Subject: RE: Fwd: RE: AERO Design AS350 Ski Basket - Dual Basket Installation Query

This query is with regards to our (AERO Design) AS 350 Ski Basket approved: SH08-16, NAPA: C-08-0181. You have flight-tested the various configurations of this basket installation.

We have a customer who had purchased our AS350 ski basket (the long 78401 basket). It is of the low mounted, right hand side configuration. They would like to purchase a second basket for installation on the opposite side so that they can operate with dual baskets.

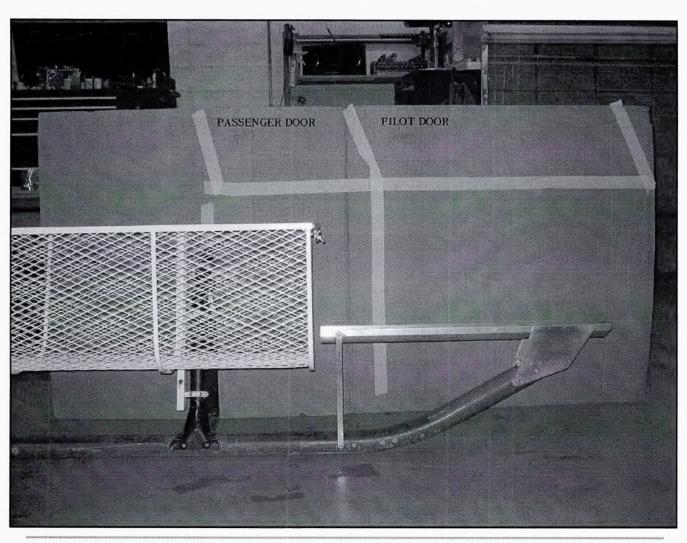
1. Our basket does not interfere with the either the passenger or pilot doors (see Picture 1);

For our part, we are currently working on an AS350 step (see <u>Picture 3</u>) as a comfort item; however we do not consider this step to be a requirement for emergency egress.
